Rep No.B14031

Fuji Electric FA Components & Systems CO., Ltd.

Notice of Changing the G-TWINΛ Series Types N/V External Operating Handle

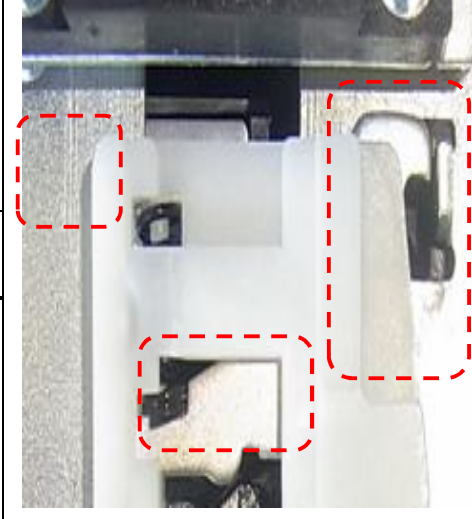
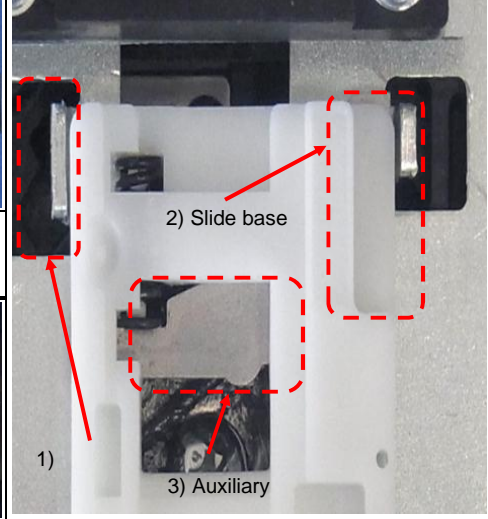
Product names	Auto breaker, earth leakage circuit breaker
Series and series name	G-TWINΛ Series types N/V external operating handle
Types	BW9N0BA, BW9V0BA (including special products)
Changed parts	Mounting plate, slide base, and auxiliary plate
Details of the change	The shape of mounting plate, slide base, and auxiliary plate will be changed. * For details, please see "Notice of Changing the G-TWINΛ Series Types N/V External Operating Handle".
Reason for change	For improving productivity
Date of production change	The changed products are scheduled to be produced from June 2015.
Attachments	"Notice of Changing the G-TWINΛ Series Types N/V External Operating Handle"
Notes concerning the change	This change does not have any effect on the performance, and the external or mounting dimensions of the products.

Target products	Before change		After change		Details of the change
Type N handle BW9N0BA					1) Mounting plate: The guides are mounted on both sides in order to stabilize the motion of the slide base. 2) Slide base: The shape is made straight by adding guides on both sides 3) Auxiliary plate: The shape is made straight by adding guides on both sides
Type V handle BW9V0BA
